**ALERT SERVICE BULLETIN**  
**Bell Helicopter** **TEXTRON**

NO. 206-04-101

**MODEL AFFECTED:** 206A/B-SERIES

**SUBJECT:** TAIL ROTOR BLADE 206-016-201-131, CHECK AND REMOVAL FROM SERVICE OF.

Figure 1. Inspect the doubler for edge void on both sides of the blade

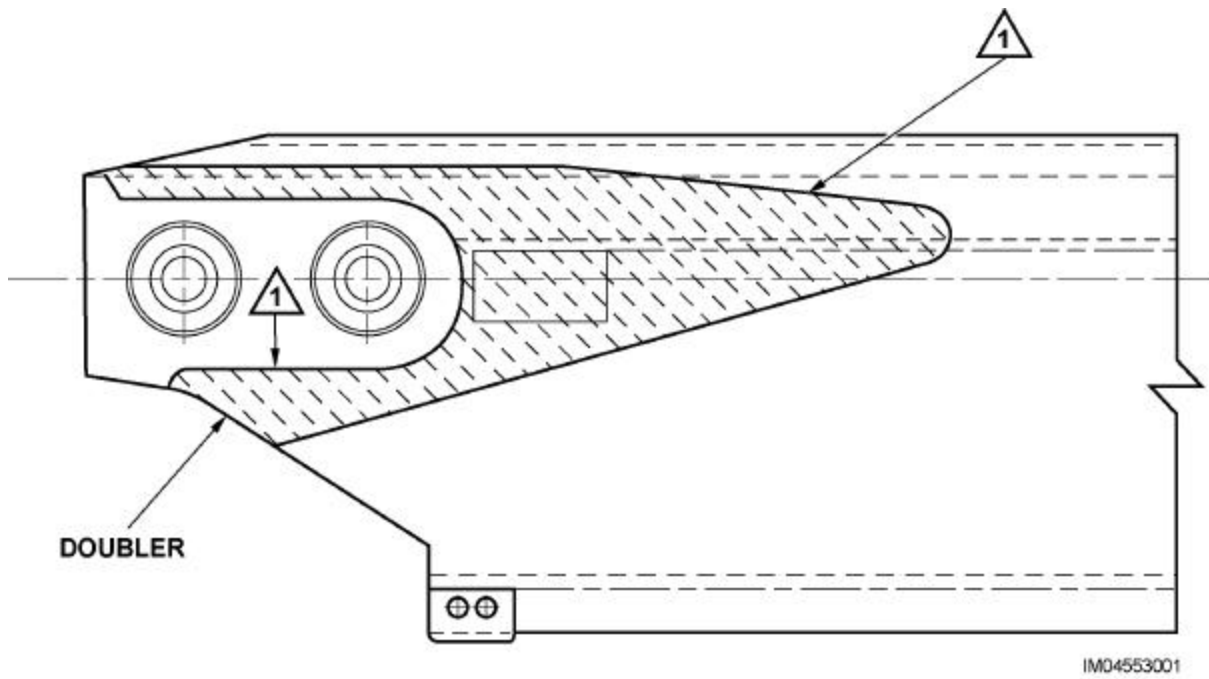
1. Use detergent (C-318) and thoroughly clean the area to be checked on both sides of the blade. Refer to figure 1.
2. Check both sides of the blade at the area indicated on figure 1 as follows:
  - a. Visually inspect the doubler for edge void on both sides of the blade.
  - b. If void or de-bonding is found, remove the blade from service immediately.
3. If no void or de-bonding is found, the blade is serviceable continue Part I until Part II is completed.
4. Make log book entries to show that the PART I of this Alert Service Bulletin has been accomplished.

Inspect the doubler for edge void or evidence of de-bonding on both sides of the blade.
